***Subject: ADDENDUM #2 – SCO ID# 19-21349-02B; Code # 41923; Item # 304 – UNC PARCS Design***

## UNC PARCS Improvements (SCO# 19-021349-02B)

### Addendum 02 - Narrative

# UNC PARKING ACCESS AND REVENUE CONTROL SYSTEM DESIGN

## TELECOMMUNICATIONS RISER DIAGRAMS & DETAILS

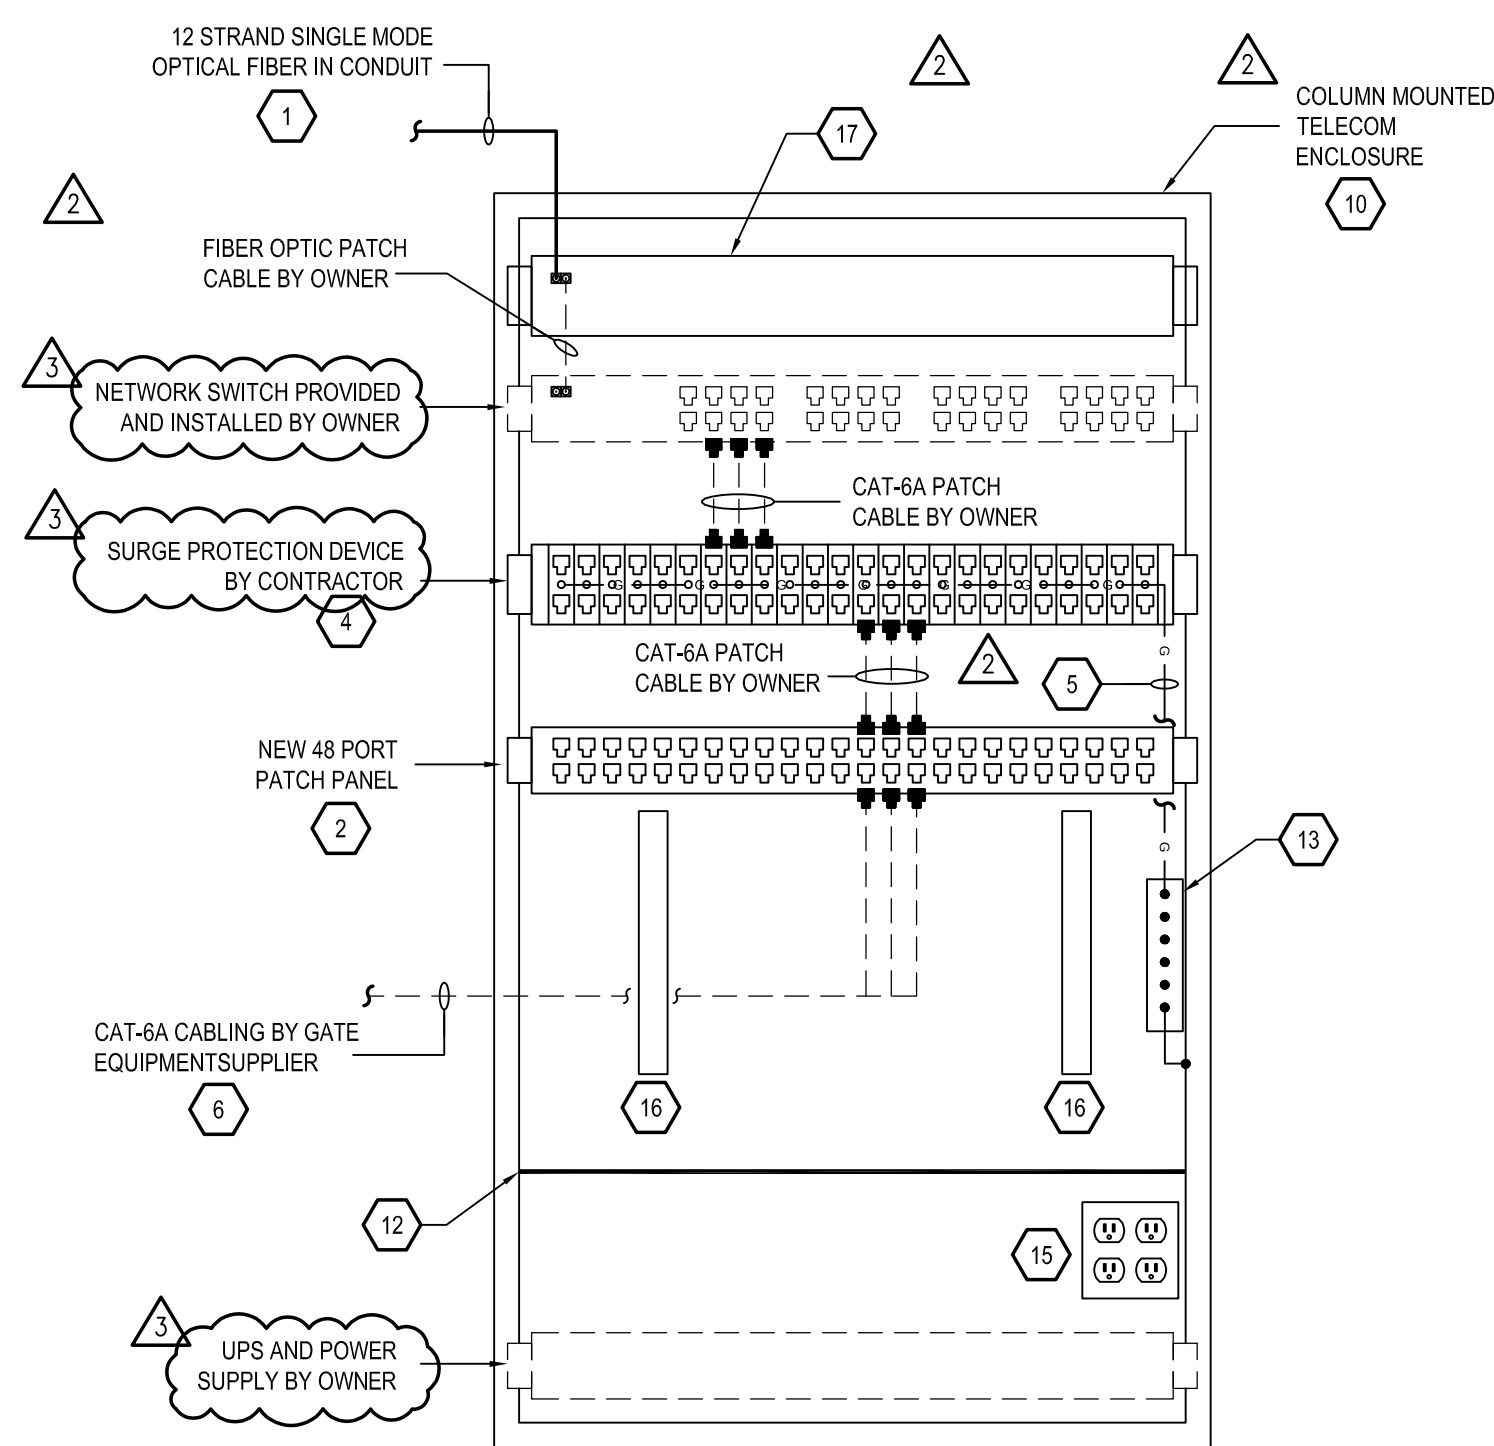
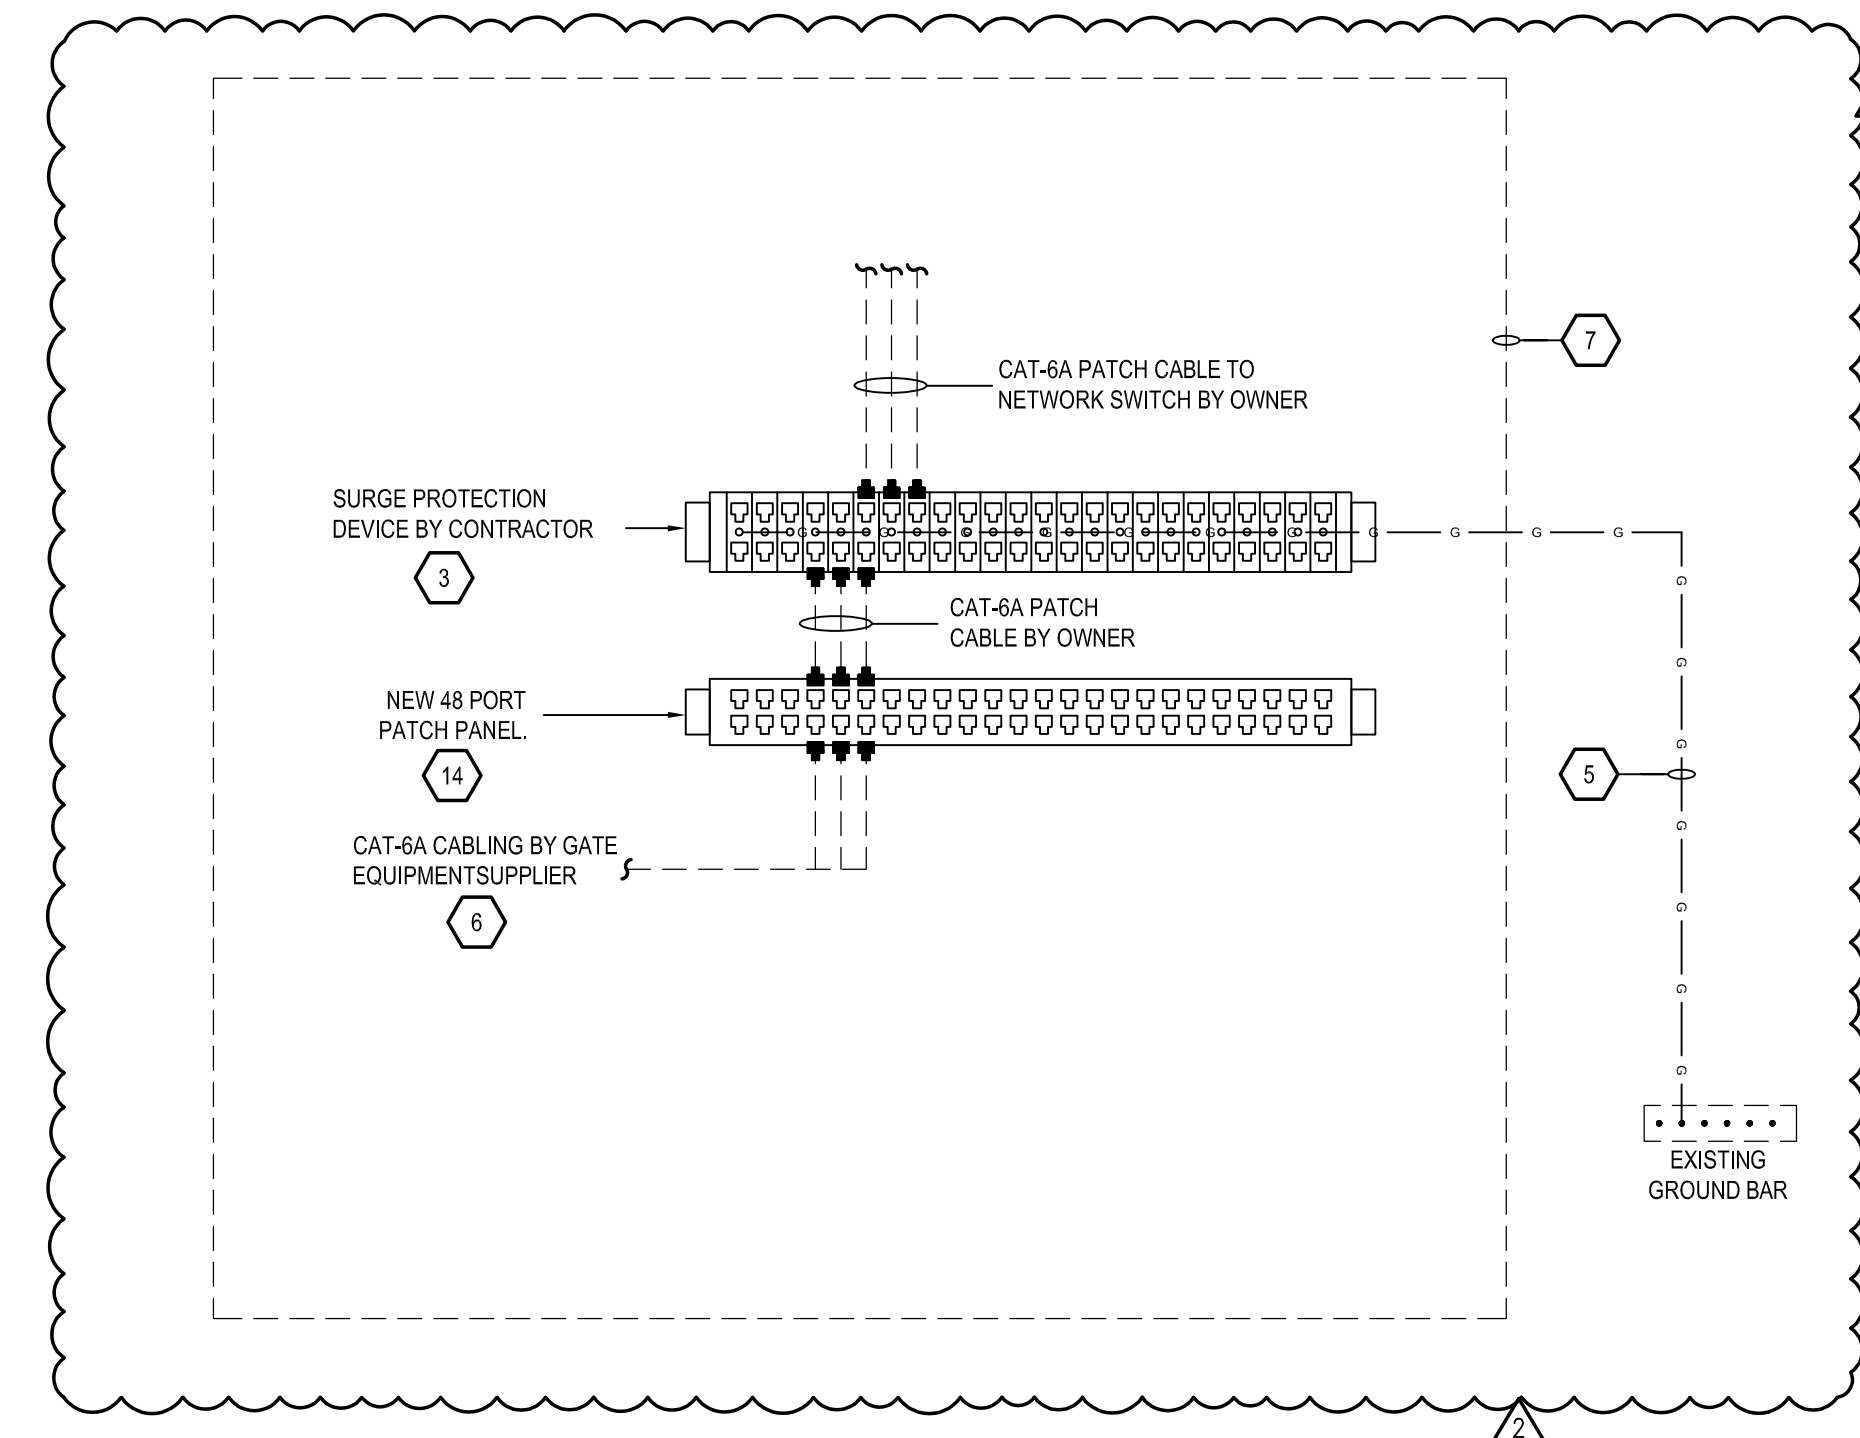
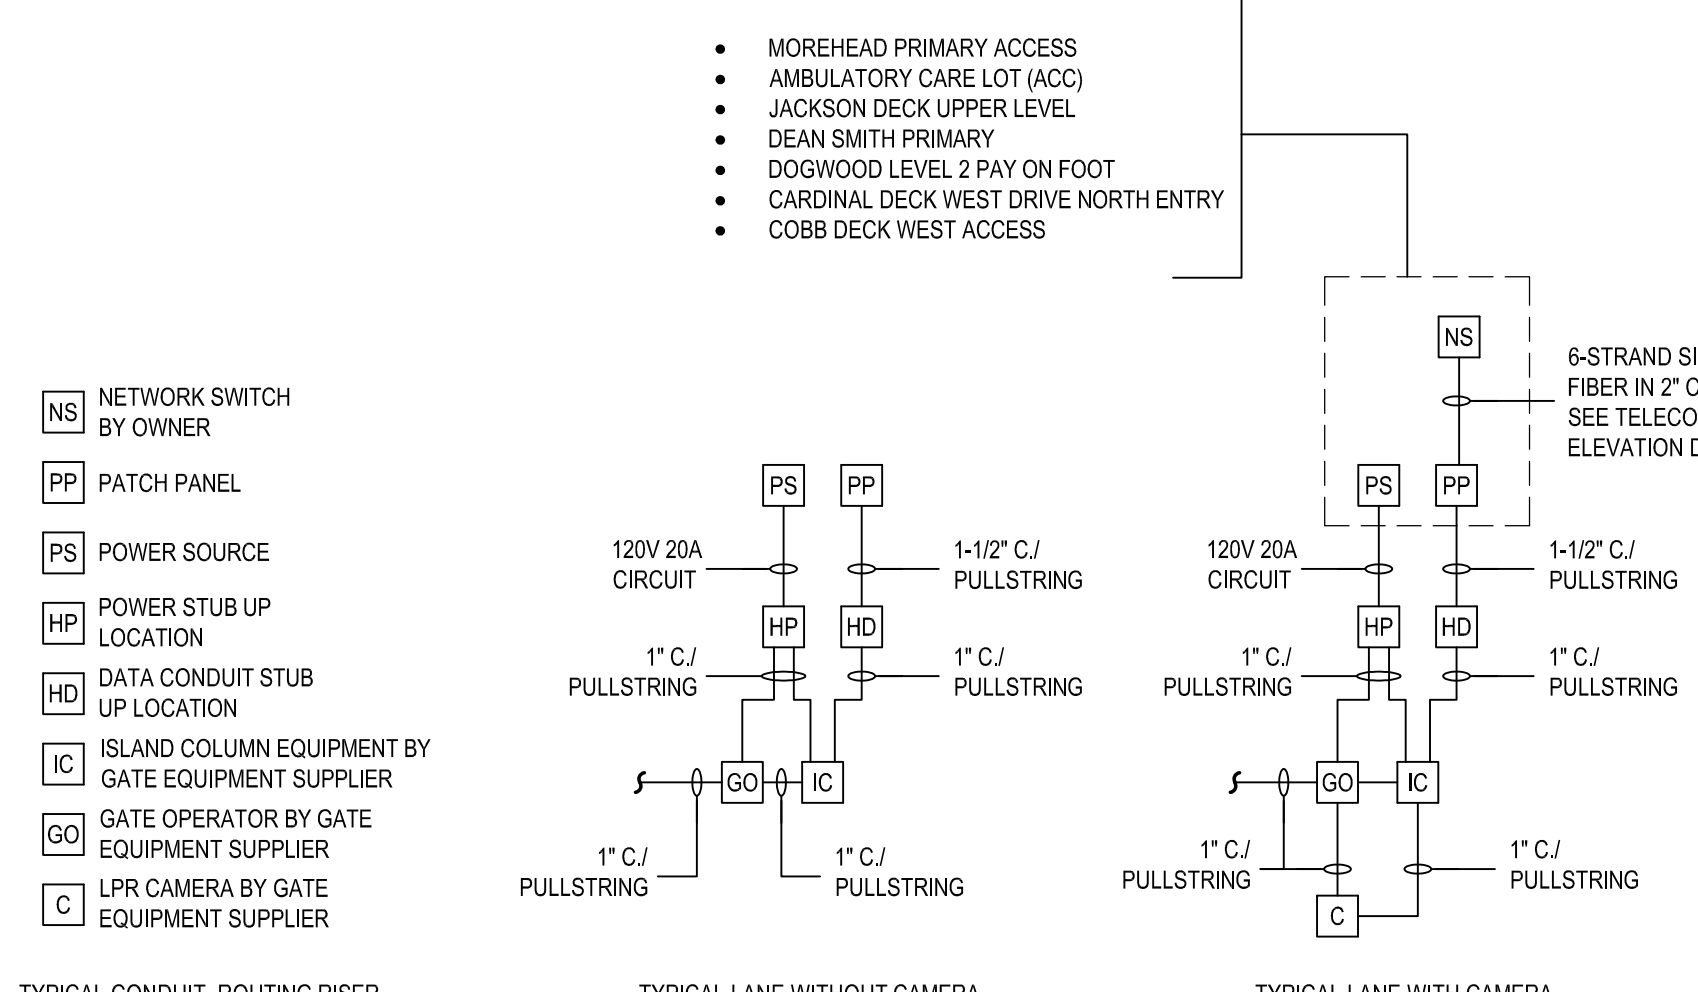
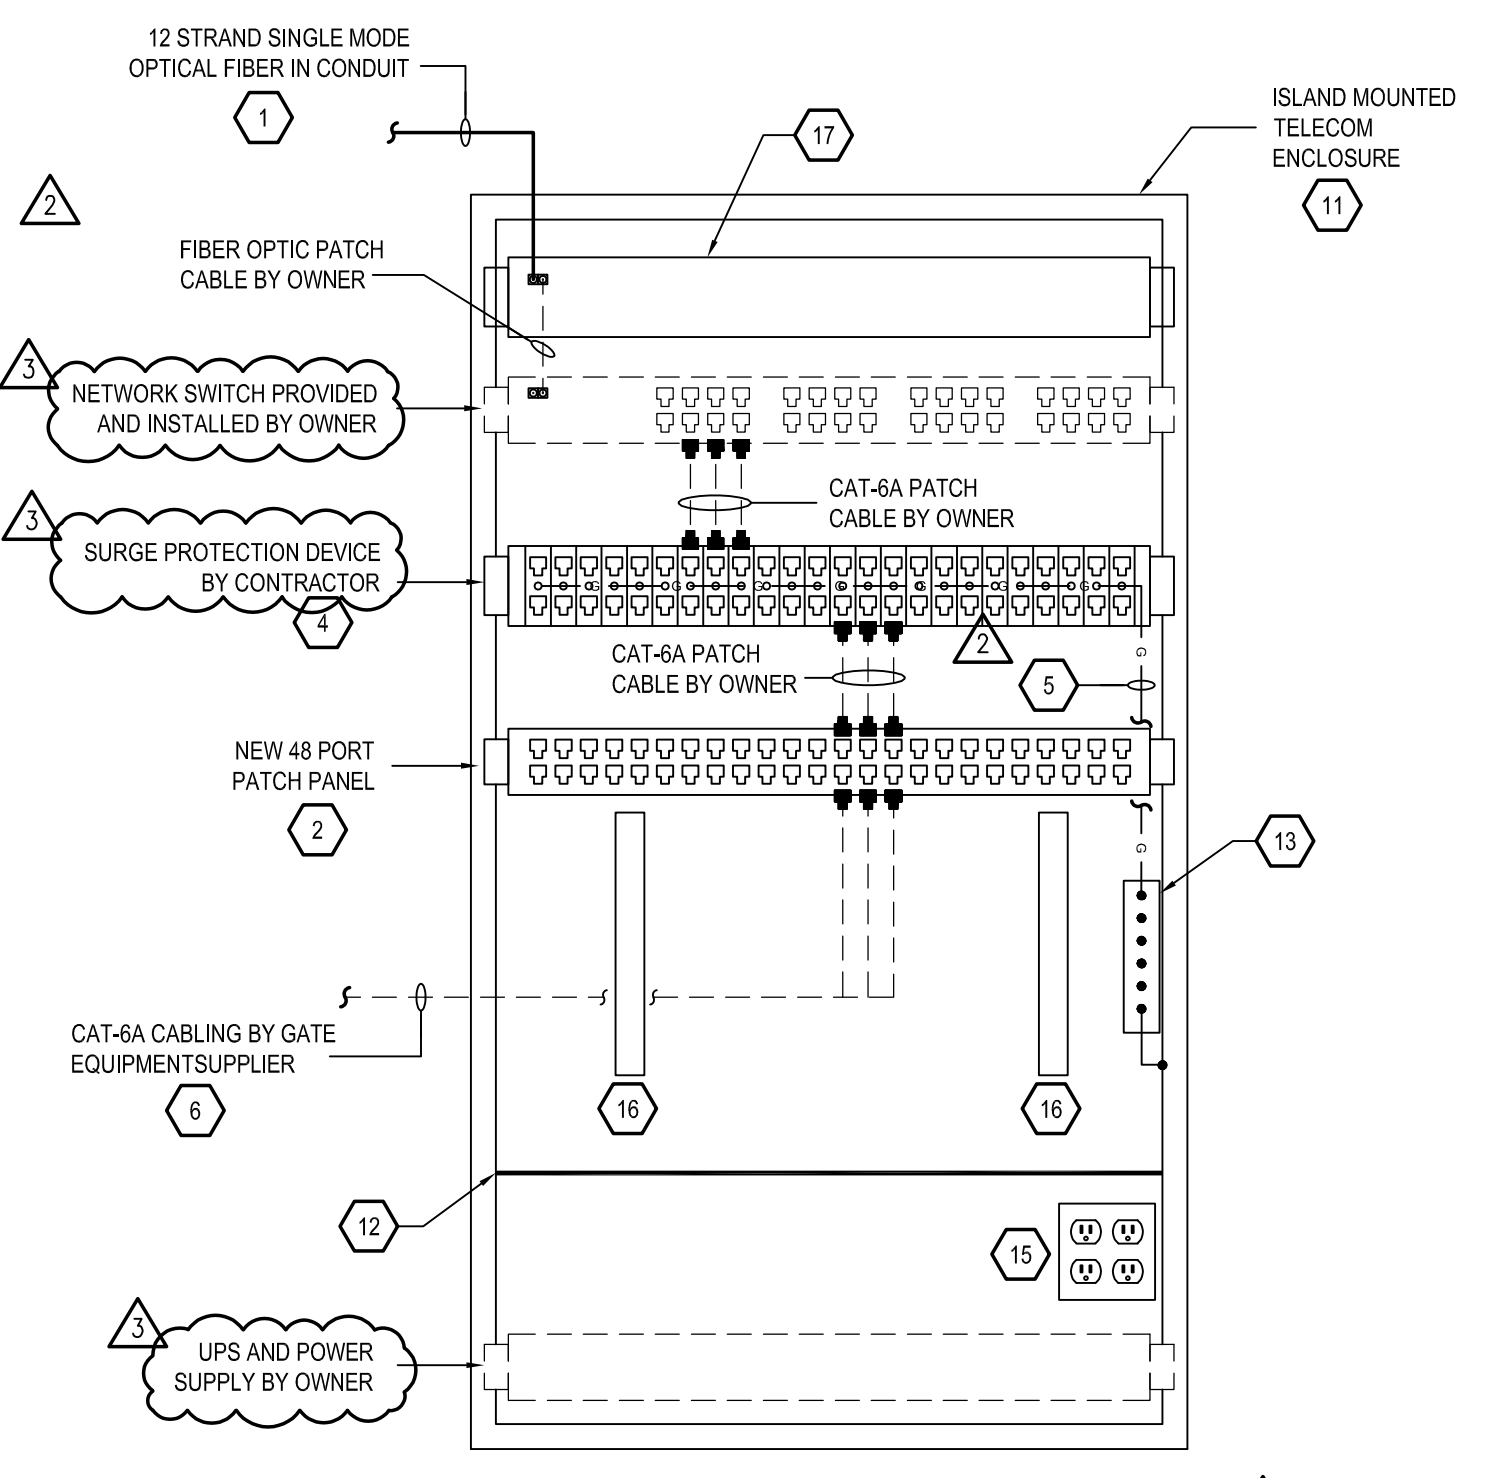
- 8 NOT USED.
- 9 NOT USED.
- 10 CONTRACTOR SHALL PROVIDE A WALL MOUNTED, NEMA 3R ENCLOSURE FOR HOUSING EQUIPMENT AS SHOWN. ENCLOSURE SHALL BE A MINIMUM 36"H x 24"W x 30"D AND INCLUDE DOUBLE HINGED / LOCKABLE DOOR WITH REAR ACCESS WITH A 19" WIDE OPEN FRAMED EQUIPMENT RACK AS REQUIRED FOR SECURING EQUIPMENT SHOWN. ENCLOSURE SHALL ALSO INCLUDE A NON-METALLIC CABLE MANAGEMENT SYSTEM WITH REMOVABLE COVER AS REQUIRED FOR SECURING AND NEATLY ARRANGING CABLING WITHIN. FINAL DIMENSIONS OF ENCLOSURE IS TO BE DETERMINED BY CONTRACTOR BASED ON ACTUAL EQUIPMENT PROVIDED / INSTALLED WITH AN ADDITIONAL 20% GROWTH CAPACITY. REFER TO SPECIFICATIONS FOR ADDITIONAL REQUIREMENTS AND COORDINATE OWNER PROVIDED EQUIPMENT DIMENSIONS / REQUIREMENTS TO ENSURE THERE IS ADEQUATE SPACE WITHIN THE ENCLOSURE.

- 11 CONTRACTOR SHALL PROVIDE AN EXTERIOR RATED NEMA 3R ENCLOSURE FOR HOUSING EQUIPMENT AS SHOWN. ENCLOSURE SHALL BE MINIMUM 20 RU HIGH x 24" WIDE x 30" DEEP AND INCLUDE HINGED / LOCKABLE DOOR / COVER AND HINGED BACK-PANEL WITH A 19" WIDE OPEN FRAMED EQUIPMENT RACK AS REQUIRED FOR SECURING EQUIPMENT SHOWN. ENCLOSURE SHALL ALSO INCLUDE A CABLE MANAGEMENT SYSTEM FOR SECURING AND NEATLY ARRANGING CABLING WITHIN. FINAL DIMENSIONS OF ENCLOSURE IS TO BE DETERMINED BY CONTRACTOR BASED ON ACTUAL EQUIPMENT PROVIDED / INSTALLED WITH AN ADDITIONAL 20% GROWTH CAPACITY AND THE ABILITY TO FIT INSIDE THE ISLAND FOOTPRINT WHERE INSTALLED. REFER TO SPECIFICATIONS FOR ADDITIONAL REQUIREMENTS AND COORDINATE OWNER PROVIDED EQUIPMENT DIMENSIONS / REQUIREMENTS TO ENSURE THERE IS ADEQUATE SPACE WITHIN THE ENCLOSURE. REFER TO NOTE 1 OF "REMOTE NETWORKING ENCLOSURE REQUIREMENTS" ON SHEET E2002 FOR ADDITIONAL REQUIREMENTS.
